SERVICE BULLETIN

APPLICABILITY: 2017-19MY Legacy and Outback
SUBJECT: DTC B1572- Revised Immobilizer Antenna Diagnostics

NUMBER: 07-181-20
DATE: 10/16/20

NEW Description:

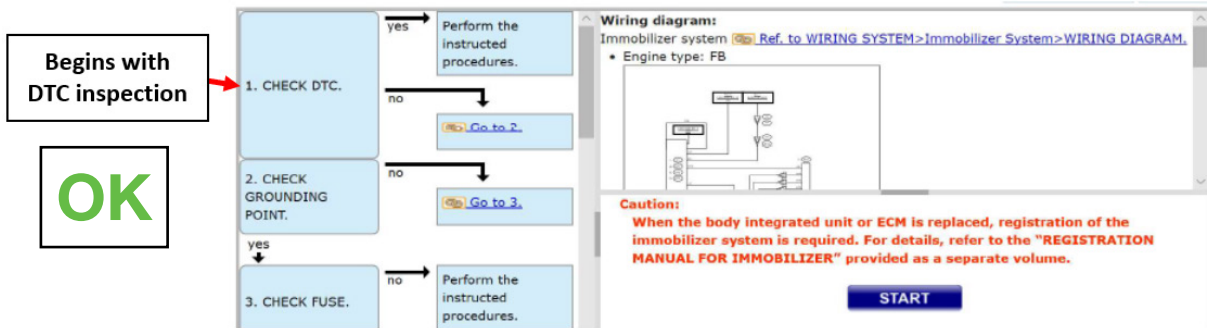
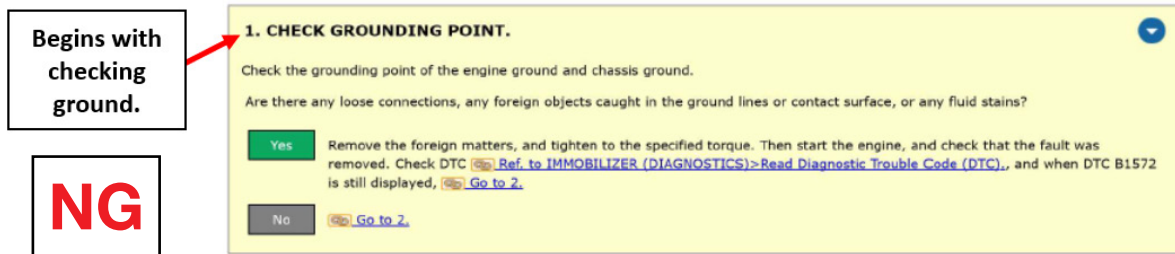
When an error occurs during communication between the engine ECM and Immobilizer Unit, DTC B1572 is recorded in the Engine ECM. When this occurs, it is **CRITICAL** to check for any stored DTCs in the Immobilizer system and perform the diagnostics for those stored DTCs **BEFORE** starting B1572 diagnosis. This very important DTC inspection step is currently missing in the Service Manual. As a result, unnecessary parts replacement may occur. Both the NEW and OLD (current, for reference) Service Manual descriptions are supplied below.

- This change is applicable in the LEGACY/OUTBACK Service Manual, section: IMMOBILIZER (DIAGNOSTICS) > Diagnostic Procedure with Diagnostic Trouble Code (DTC) > DTC B1572 only.
- This change is **NOT APPLICABLE** to section “KEYLESS ACCESS WITH PUSH BUTTON START SYSTEM (DIAGNOSTICS) > Diagnostic Procedure with Diagnostic Trouble Code (DTC) > DTC B1572”.
